IREDELL COUNTY HEALTH DEPARTMENT
ENVIRONMENTAL HEALTH DIVISION
Application For Improvement Permit
Site Plan Form

Mills Forest Lot 5 II

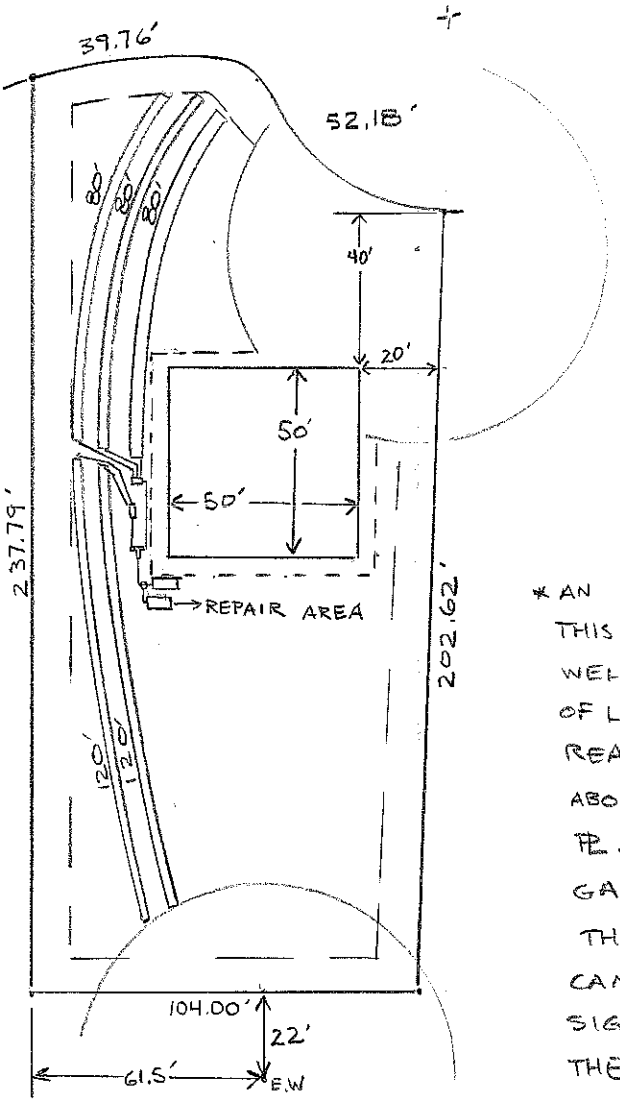
LATERALS SKETCHED DO NOT SHOW EXACT CONTOURS, BUT DO SUGGEST THE POSSIBILITY OF A CONVENTIONAL ORIGINAL AND LPP REPAIR.

* AN ALTERNATE LAYOUT FOR THIS LOT WOULD BE WITH WELL AT REAR CENTER OF LOT ABOUT 10' FROM REAR PL AND HOUSE ABOUT 50' FROM REAR PL. NOTHING MAY BE GAINED BY THIS AS THE WELL ON LOT 6 CANNOT BE MOVED TO SIGNIFICANTLY REDUCE THE ENCROACHING WELL SETBACK RADIUS.
